Responses to NRC Letter Dated August 19, 1997 and December 5, 1997, Regarding NRC
Acceptance Review of the Reclamation Plan for the White Mesa Uranium Mill

**Response to Nuclear Regulatory Commission / White Mesa Mill Reclamation Plan
Comments Dated August 19, 1997
Source Material License SUA-1358**

Response to Nuclear Regulatory Commission / White Mesa Mill Reclamation Plan
Comments Received December 8, 1997
Source Material License SUA-1358

Cell 2 Settlement Monitors

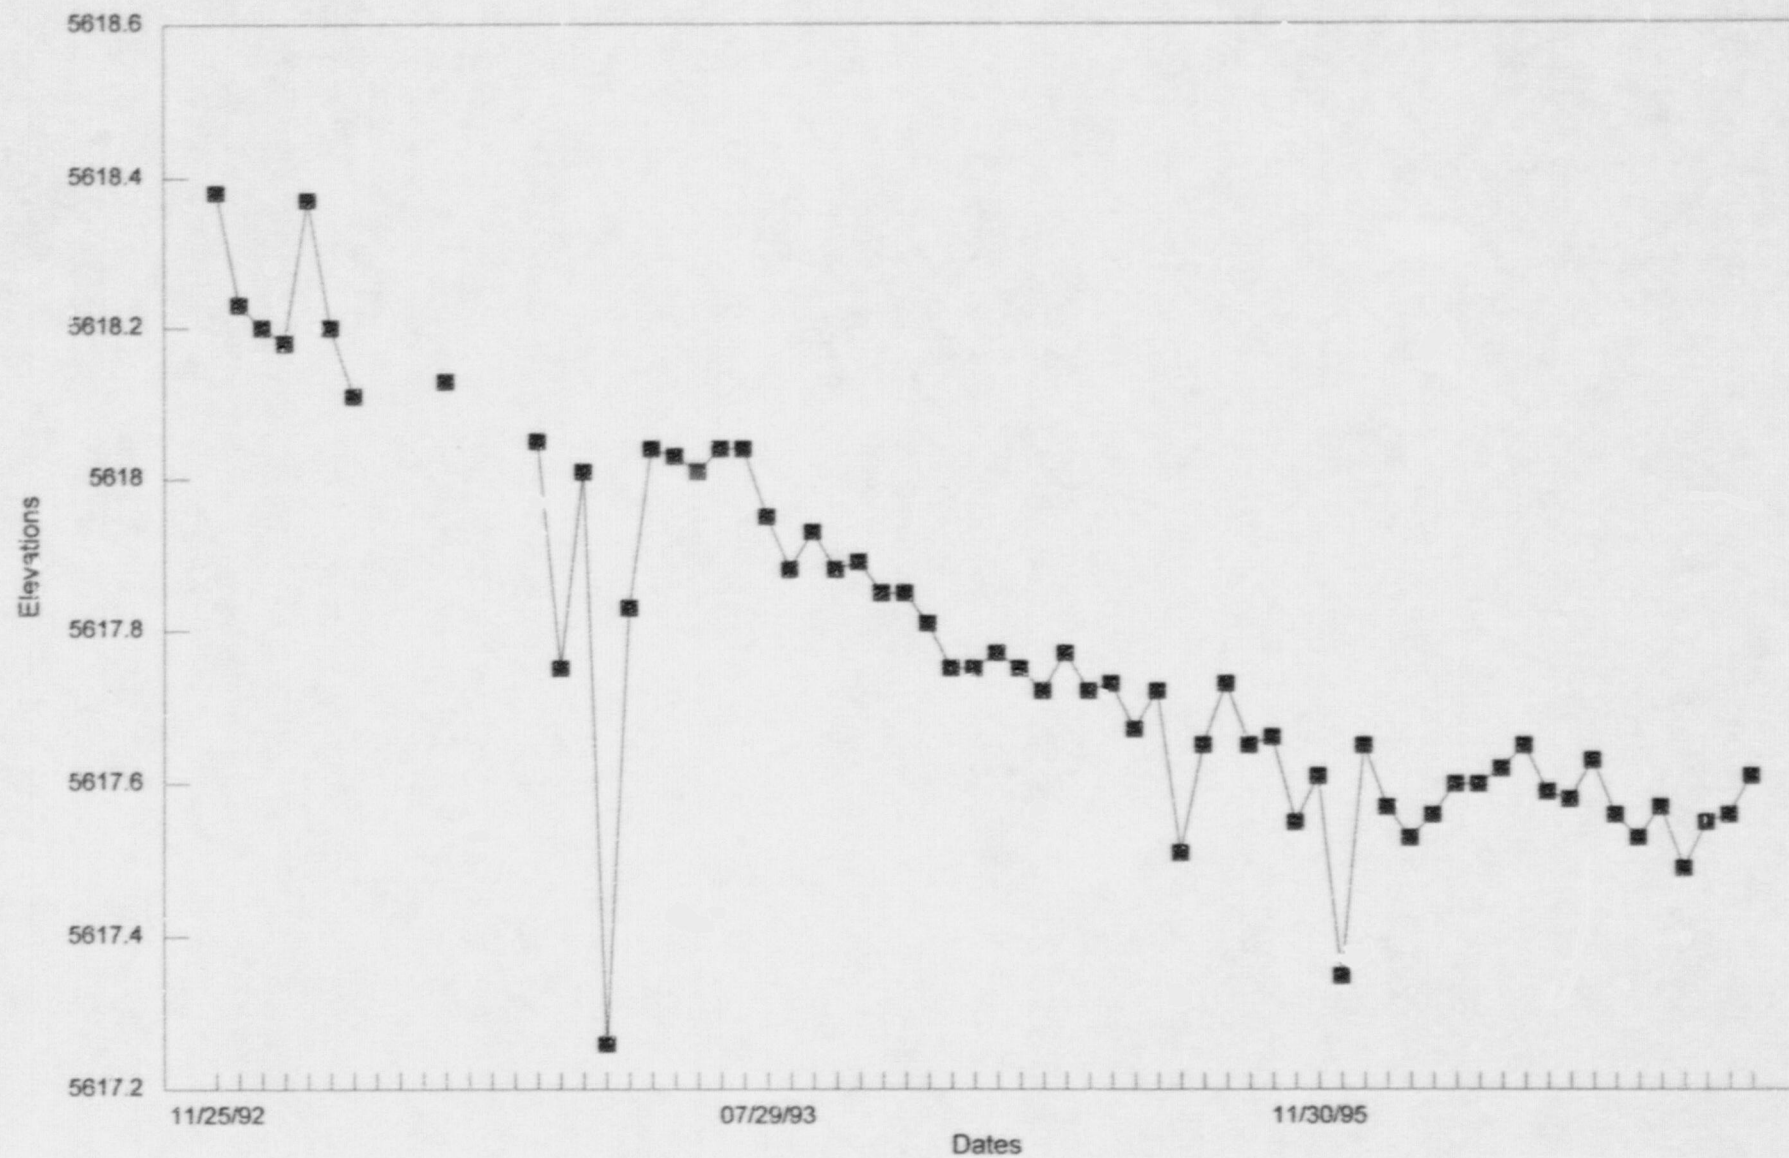
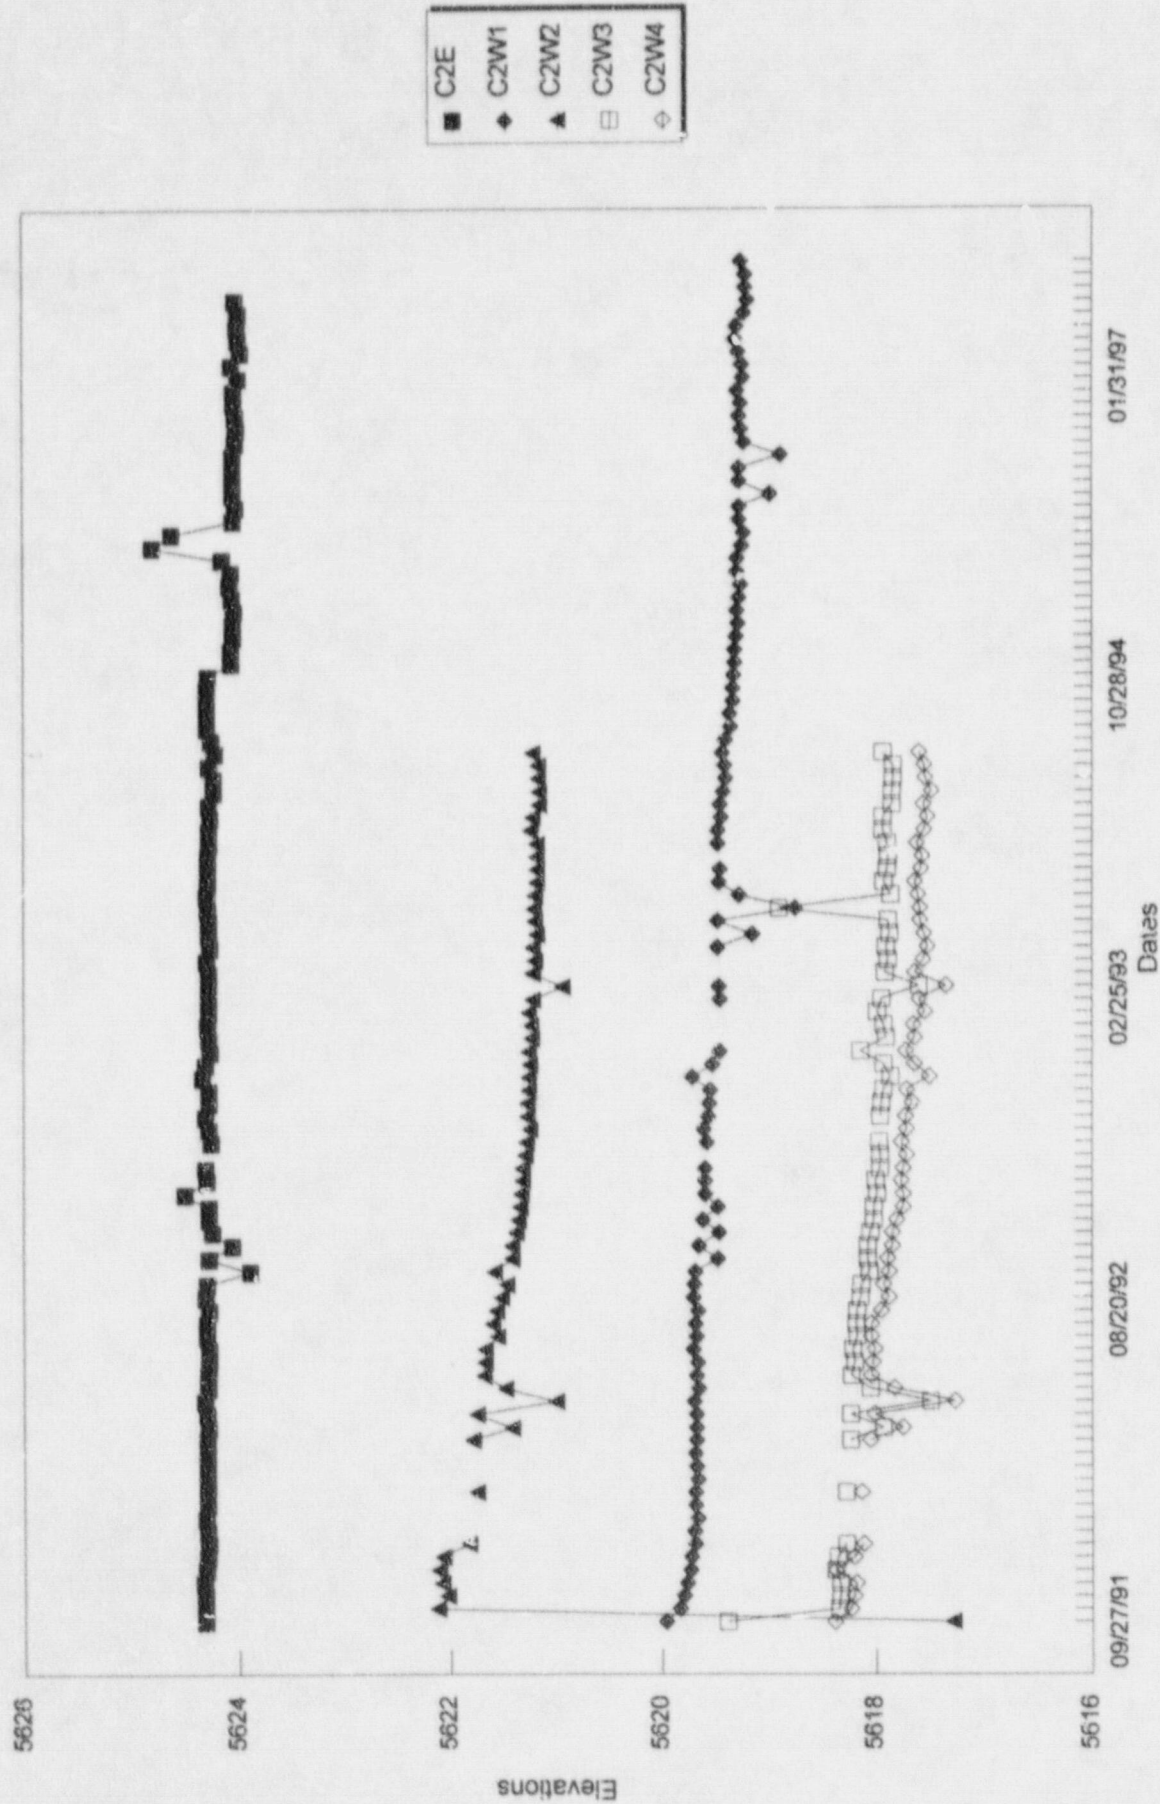
(2) An analysis of the total and differential settlements of the tailings surface and the effects of such settlements on soil cover integrity.

Analysis of the total and differential settlement of the tailings surface was performed using the survey data compiled for the five settlement monuments installed within Cell 2. These monuments were installed on the surface of the tailings, between August 1989 and November 1992, prior to the placement of approximately three to four feet of random fill material. Survey results of each monument were plotted as time vs. settlement graphs and are presented in Attachment 2 of this response.

Review of the survey data and graphs shows that primary consolidation of the tailings has occurred, and the settlement rate has been very slow with minor total values. The maximum total settlement recorded is 0.97 feet, and the differential settlement is on the order of 0.50 feet. Approximately 81 percent of the total measured settlement occurred within the initial three years. Additionally, recent survey data indicates that the settlement has virtually stopped. From September 1995 to September 1997 the settlement averaged less than 0.03 feet per year, which is within the expectable survey error of 0.05 feet. This indicates that the settlement since 1995 is negligible.

YSIS ALON CELL-4 DIKE

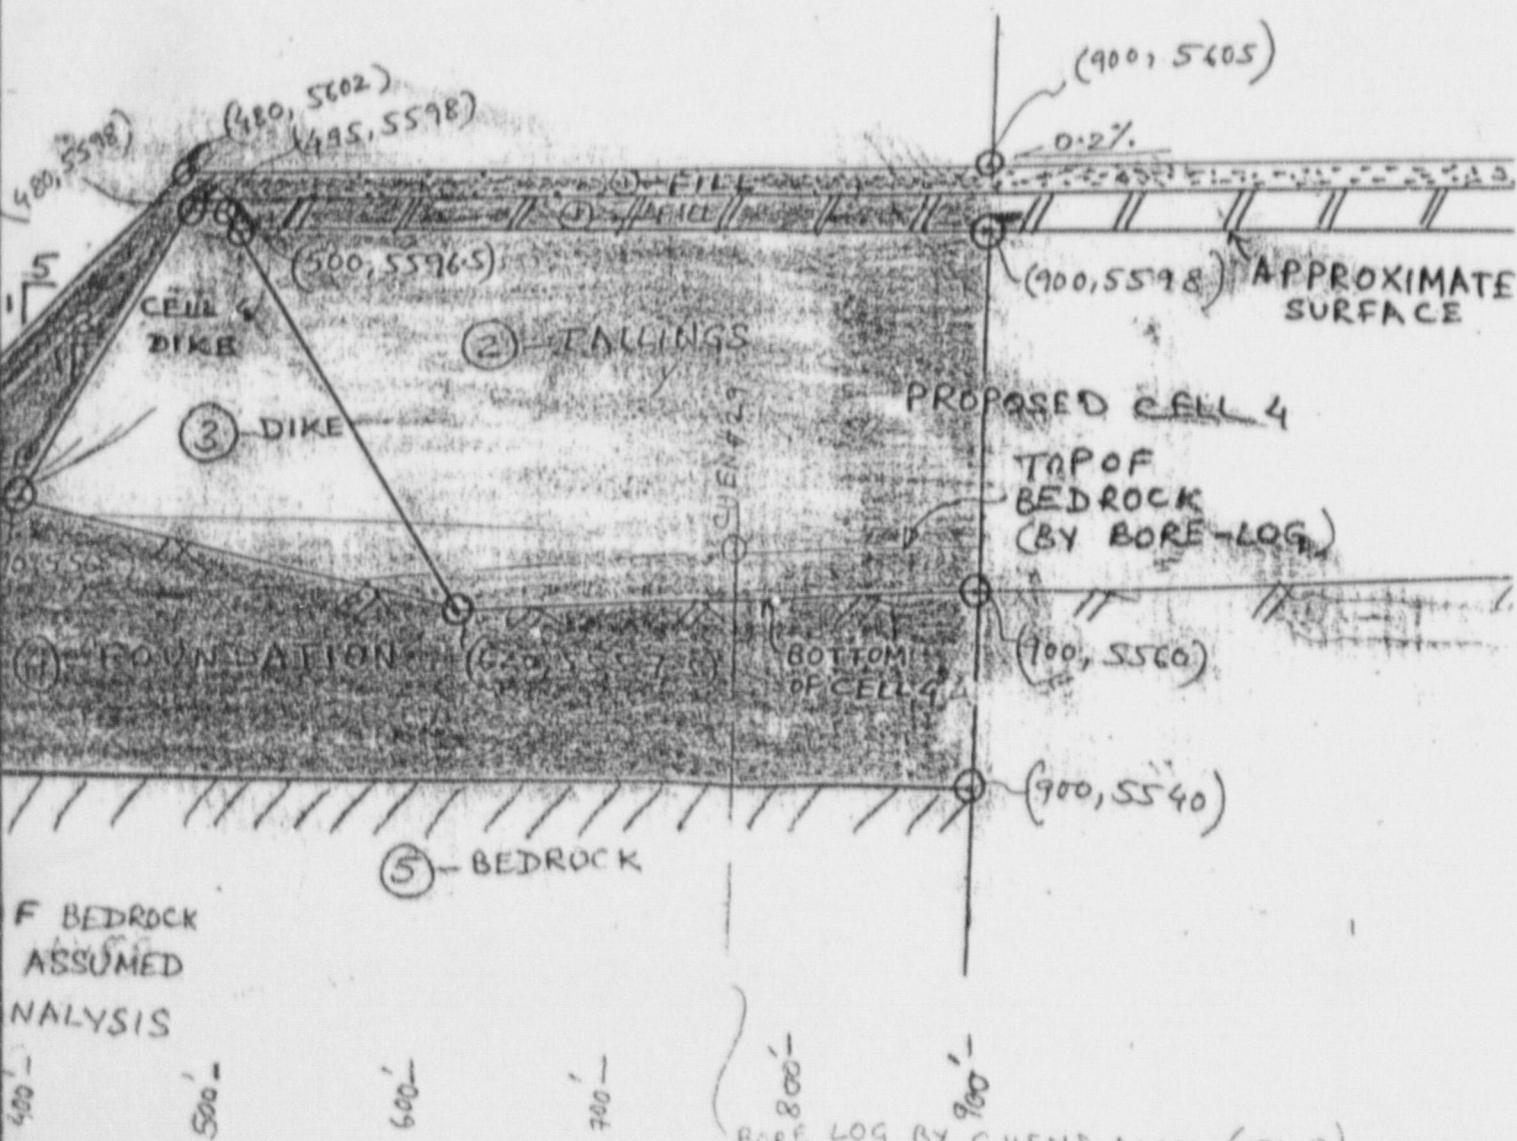
- (11) *A replacement of seven pages of illegible data. These pages are in appendix A of Appendix D [Tailings Cover Design White Mesa Mill, October 1996 (pages marked p. 12 through p. 17)] and in appendix G of Appendix D [Tailings Cover Design White Mesa Mill, October 1996 (figure showing cross-section along Cell 4 dike)].*

The seven replacement pages are included in Attachment 3 of this response.
